# ADDENDUM ONE

Kendallville Housing Authority Lamplighter - Kitchen Renovations Phase 2  
240 Angling Road  
Kendallville, IN 46755

Commission No.: F23114

Addendum Date: February 2, 2024

**1 Overall First Floor Plan**  
 1/32" = 1'-0"

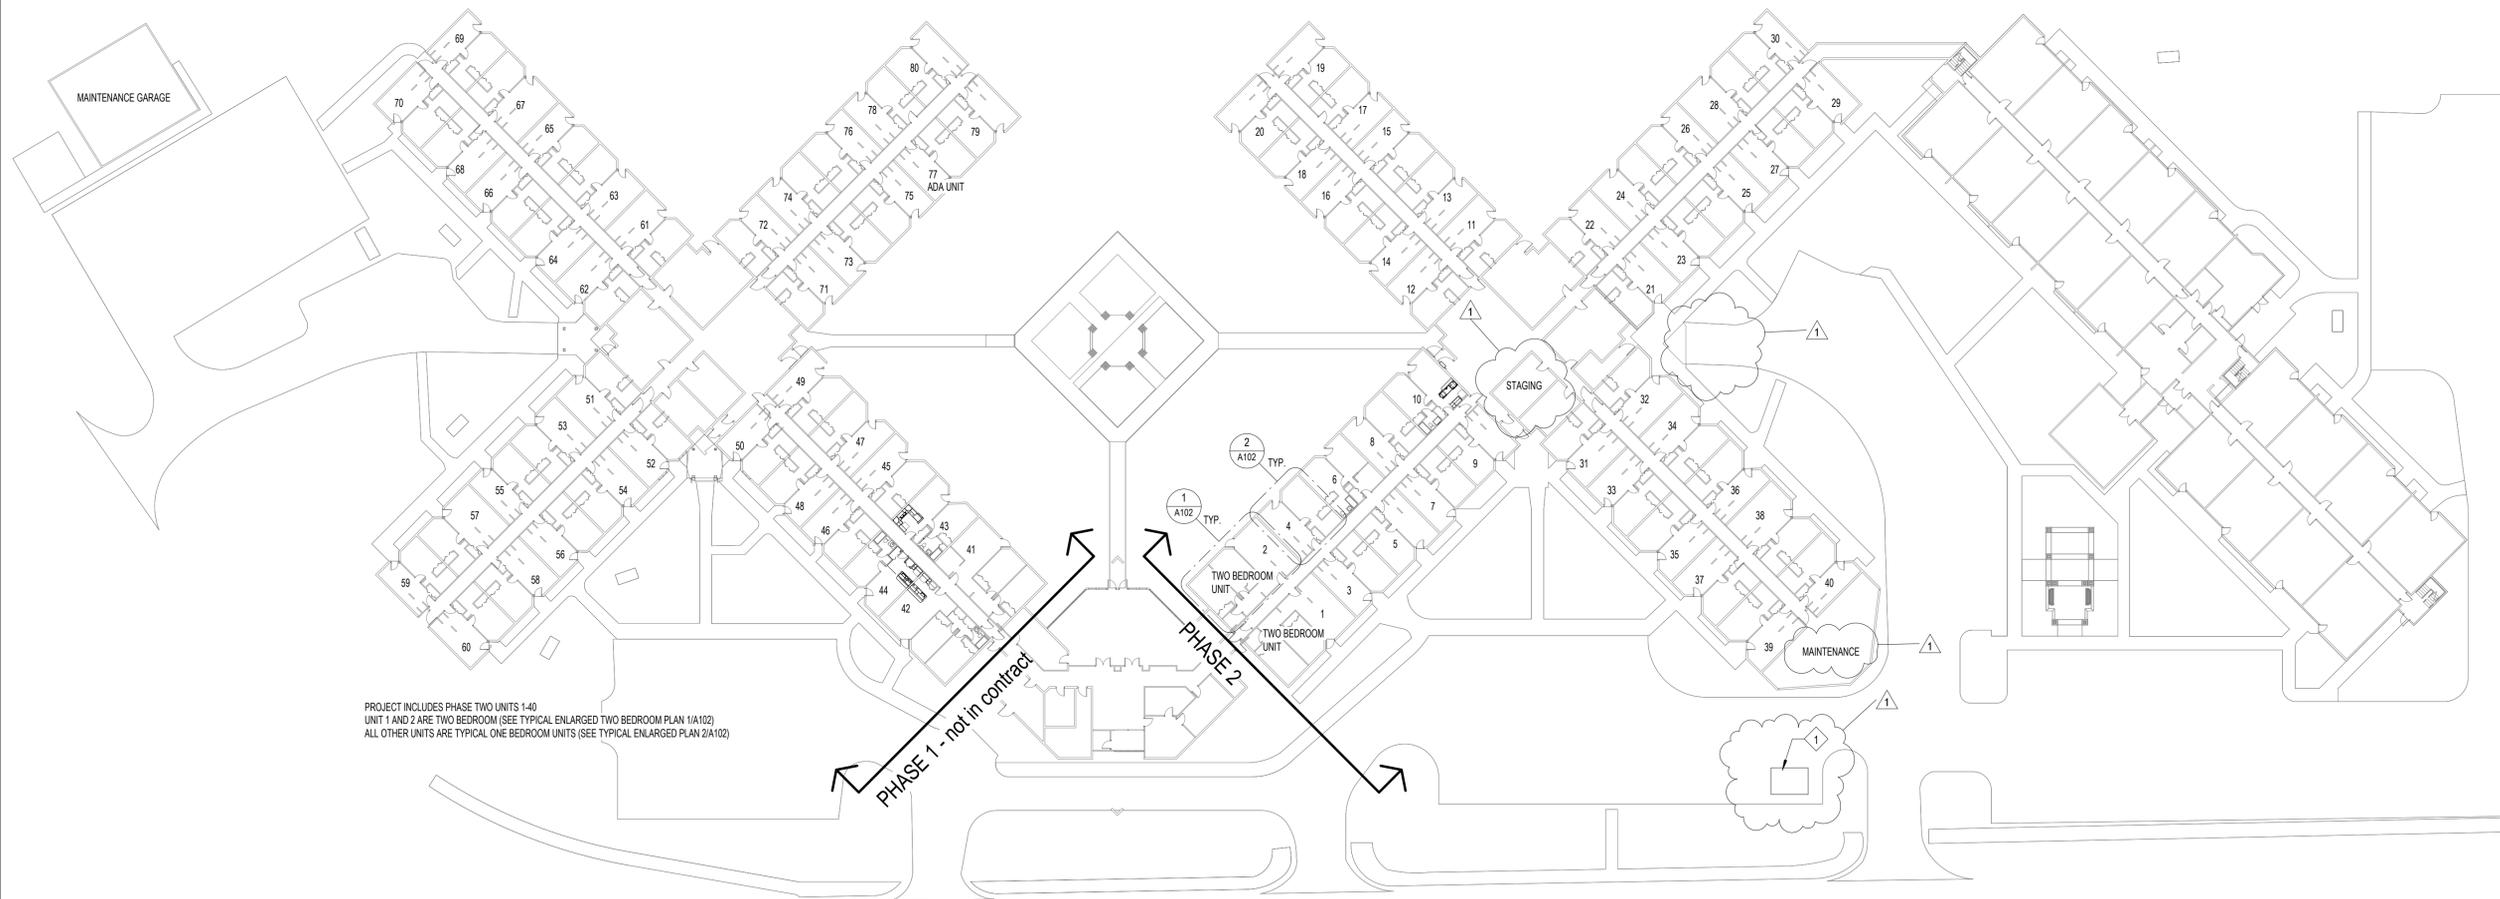
**CLARIFICATION** Portion of the existing building can be used for staging, see revised plan A101.
